ADDENDUM NO. 5

Williston Regional Water Treatment Plant Pretreatment – Part 3

Western Area Water Supply Authority
Williston, North Dakota

1
P15
 ENLARGED SUBGRADE LEVEL PLAN
 SLUDGE TANK AND PUMP AREA
 REF: P10

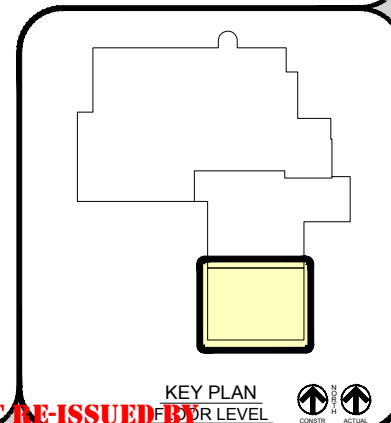
SYM	DATE	DESCRIPTION	APPR
Δ	JAN 2019	CLARIFY EXISTING	PAJ

CHEMICAL FEED SCHEMATICS

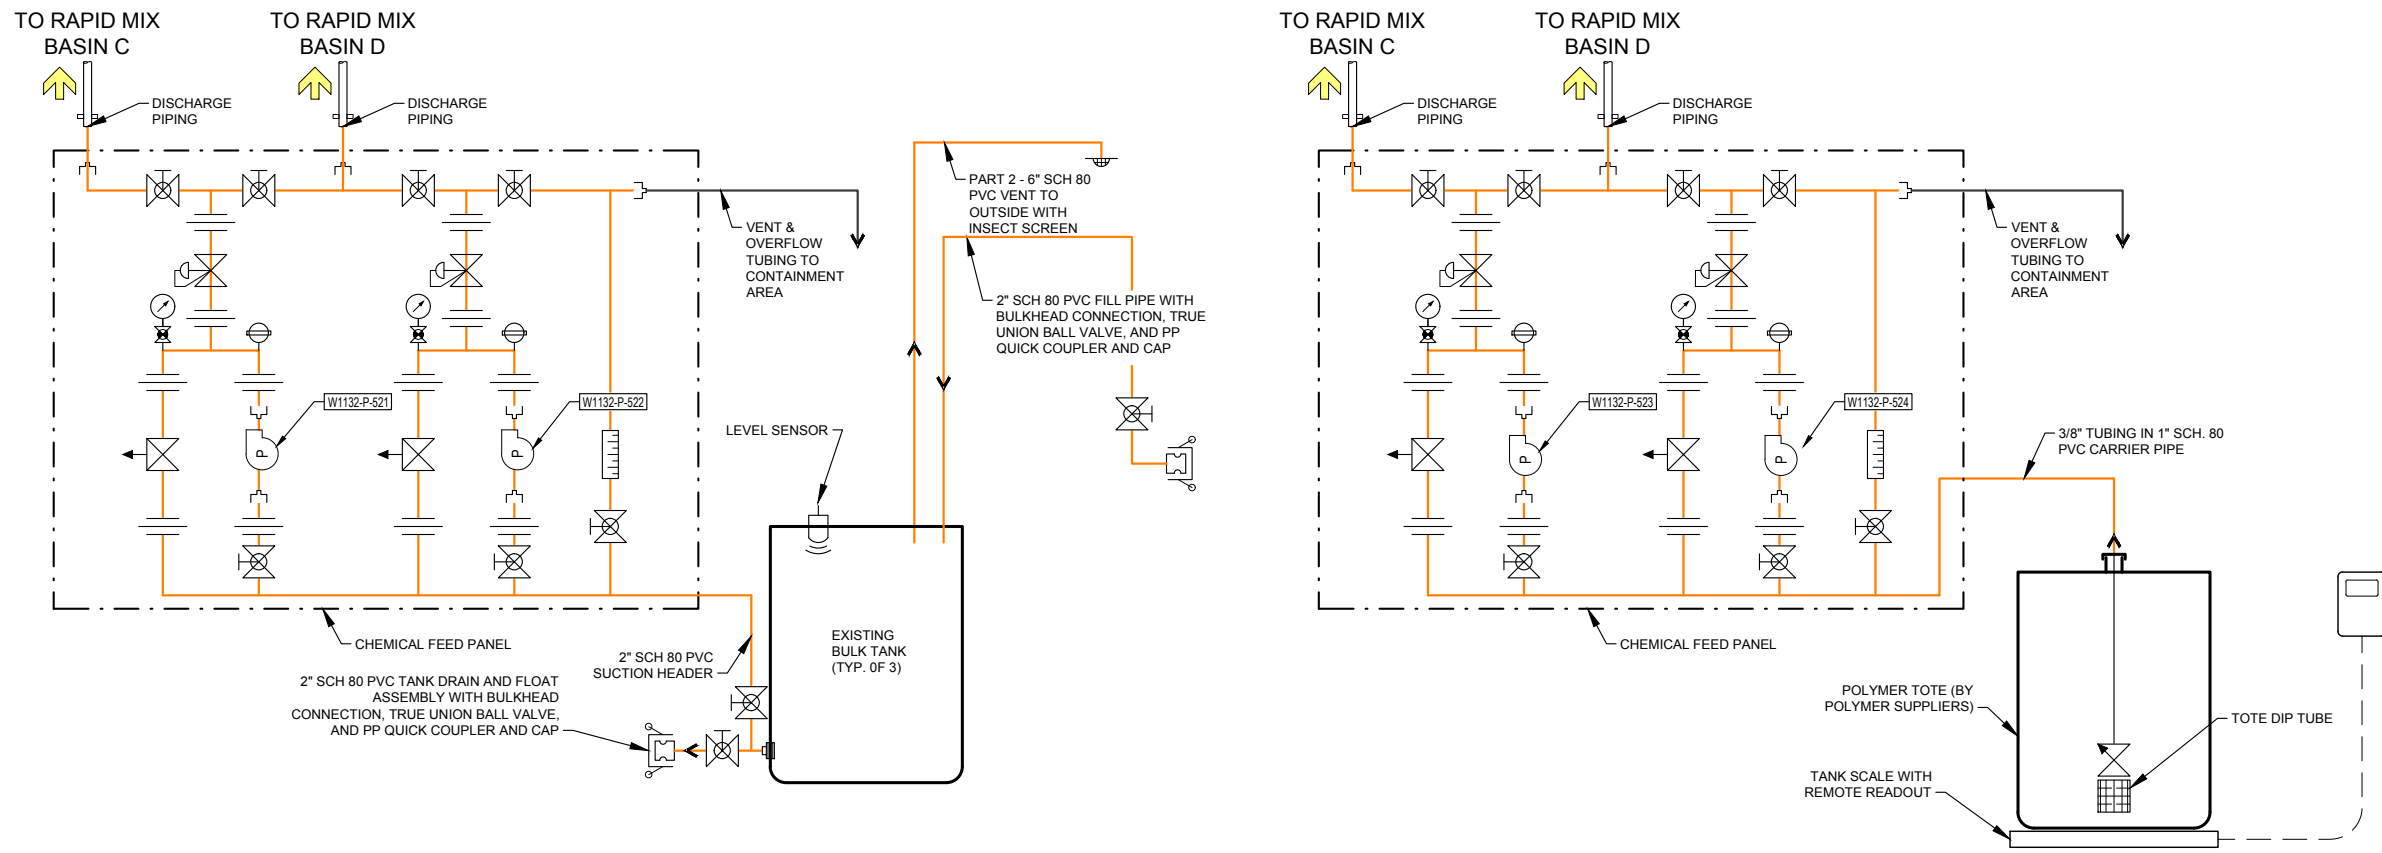
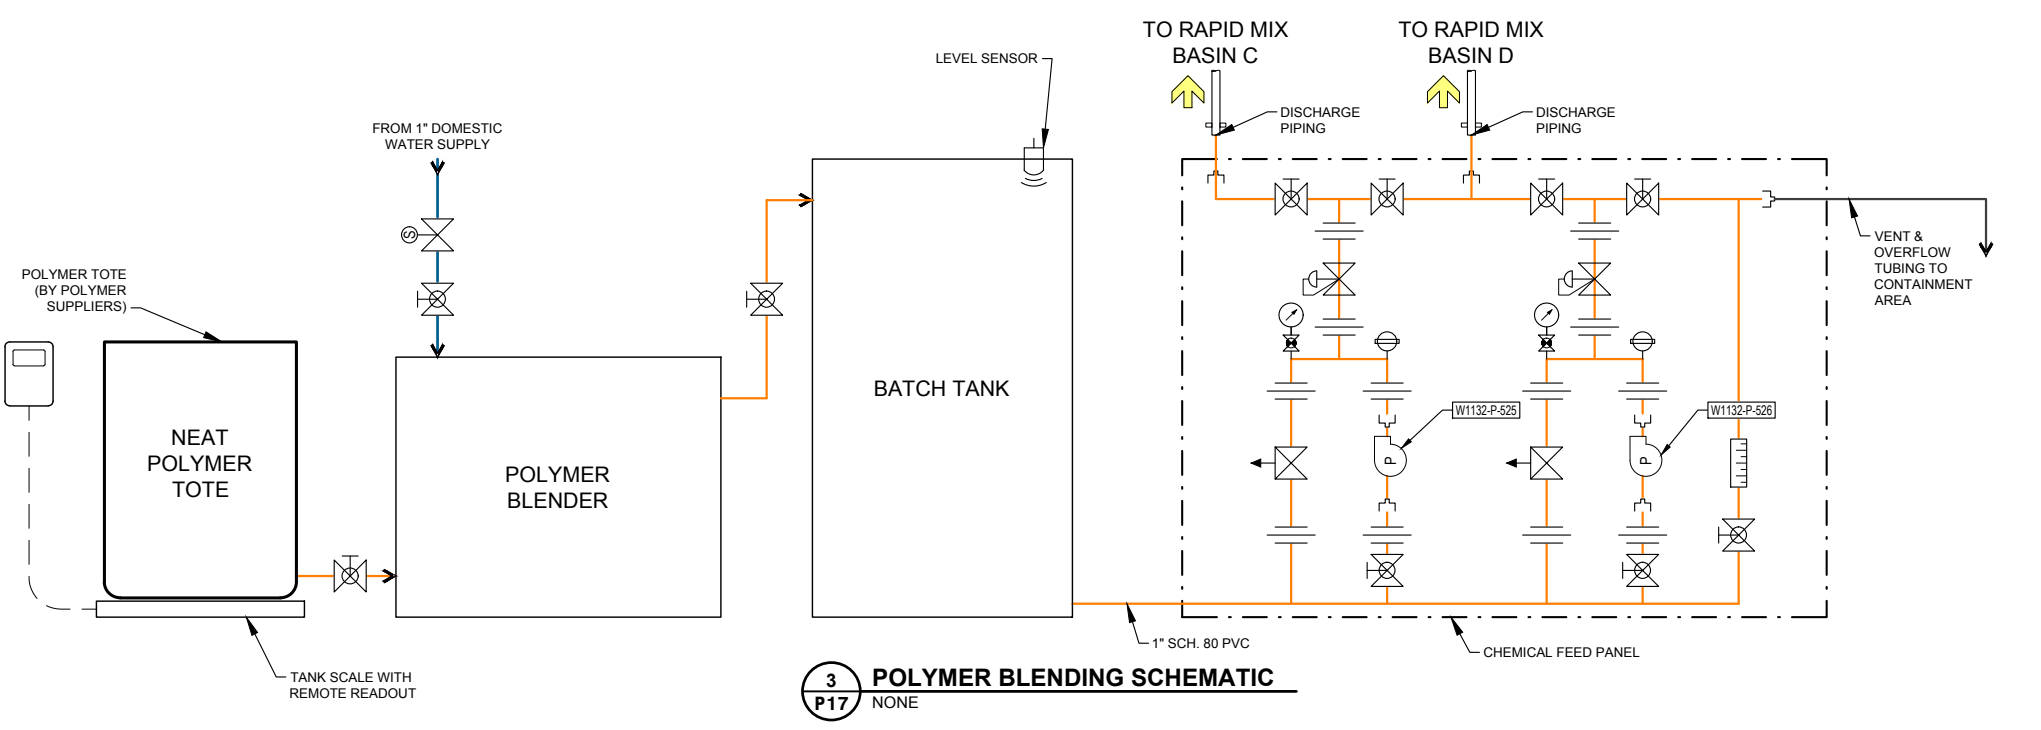
JAN 2019 CLARIFY EXISTING
